The text reproduced below reflects the state of play of the discussion of the SIG UNR157 up to its 8th meeting on raising the specified maximum speed of ALKS up to 130 km/h. It is based on ECE/TRANS/WP.29/GRVA/2020/32 (DE) and subsequent amendments received on this proposal.

Modifications to the existing text of UN-Regulation No. 157 (incl. suppl.02 to 00 series) are marked in **black bold** for new or ~~struckthrough~~ for deleted characters.

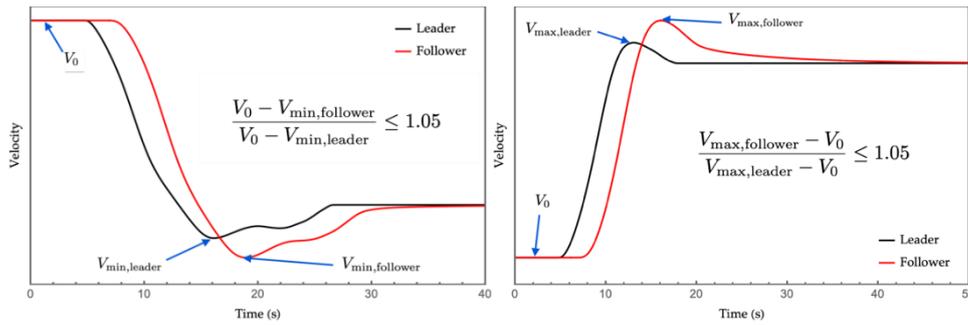
Group conclusion: Delete proposed new para. 5.2.9 and 5.2.10.

~~[5.2.10. While following another vehicle the ALKS vehicle shall aim to be string stable.~~

~~In particular, when following another vehicle at constant speed and at a distance such that the speed profile of the ALKS vehicle is influenced by the speed profile of the vehicle in front, the ALKS vehicle shall aim to respond to a perturbation in the speed of the vehicle in front with a perturbation in its speed profile by at most a 5% increase in the maximum difference in speed compared to the vehicle in front before reaching a new equilibrium velocity following the visual examples reported in the following figures.~~

Figure 1

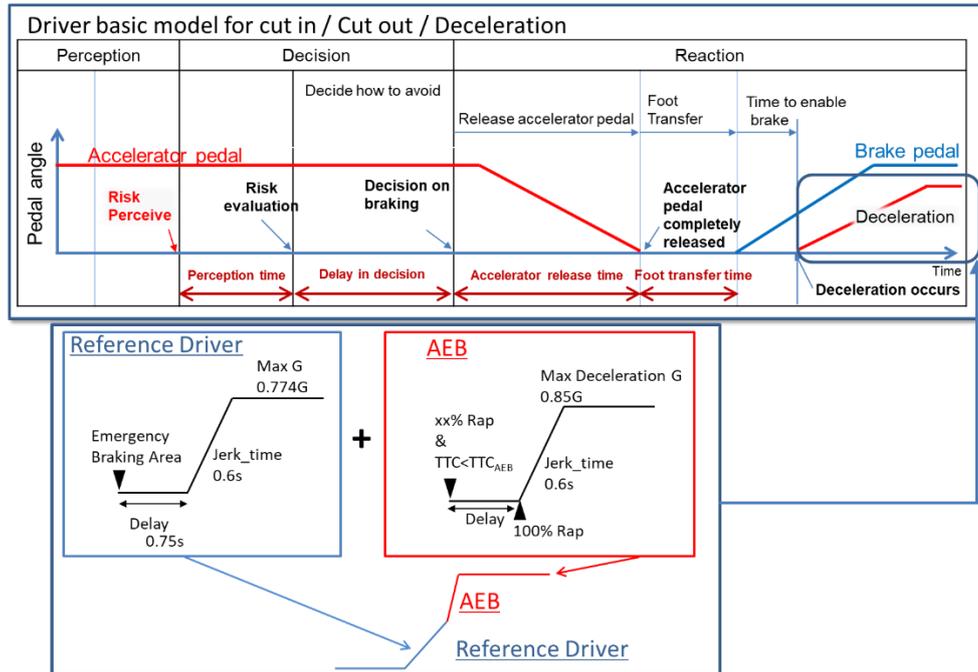
Group conclusion: agreed to amend title of figure accordingly:

~~Skilled Careful Competent~~ and ~~competent careful~~ human performance model
